MODEL: 365, 371

SUBJECT: Oil Worm Gear Field Repair

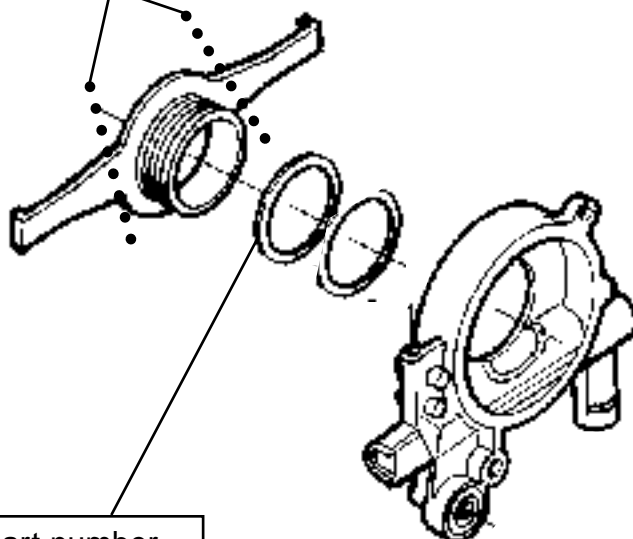
This repair can be made by removing the oil worm gear and modifying it as shown below. This will work with the white or black gear. Add one washer part number 503 23 00-59 to the existing washer as below and reinstall worm gear. This will make the oiler work as a direct drive, at idle the oil flow is minimal. To adjust oiler turn oil adjusting screw all the way in and then set oil adjusting screw to the chart.

Cut the wings off the oil gear at the dotted lines and smooth the edges.

Add a second washer part number 503 23 00-59.

Note! Be sure that two washers are used and only with the wings removed.
